HARRIS Technical Support Bulletin #1055

NetWave, RMXd, VMX Digital I-O

SUBJECT: Some digital outputs, when set to 44.1 kHz sample rate, may exhibit artifacts on certain target equipment

PRODUCT: NetWave and RMXdigital consoles & VistaMax Digital I-O cards

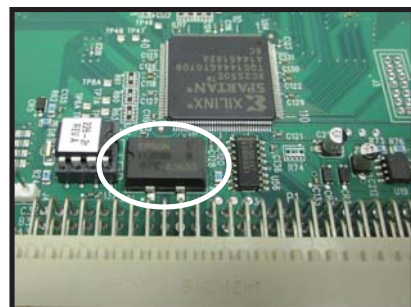
But, to generate a 44.1 kHz sample clock, the first four outputs of the VistaMax Digital I-O card, any RMXdigital KSU digital output, and any NetWave main card digital output have used an Epson 11.2896 MHz crystal. Some of these parts have had higher-than-expected clock jitter. These crystals are labeled on the top as "EPSON 11.2896" and are part XO1 on the NetWave Main card and VistaMax Digital I-O card or XO2 on RMXdigital KSUs (as shown in the top three photos).

With high clock jitter, some target equipment may exhibit artifacts, like intermittent audio dropouts, pops, or static noise with the sample rate set to 44.1 kHz. The target equipment with the most reported artifacts is the Sage Digital Endec EAS alerter.

In 2009, the EPSON crystals were replaced by an Oscilent ceramic oscillator (shown in the bottom photo). There have not been any reported problems with clock jitter when using the Oscilent part.

WHAT SHOULD BE DONE? Leave the digital outputs set to 48 kHz, if possible or, if you have not had any issues with 44.1 kHz output sample rates, then no action is required.

If you are experiencing audio artifacts (audio dropouts, pops, or other periodic noises) or if the target equipment does not work at all when the output is set to 44.1 kHz, then an advance replacement card, with an Oscilent part installed, can be sent out to exchange your original card through an Advance Replacement RMA.
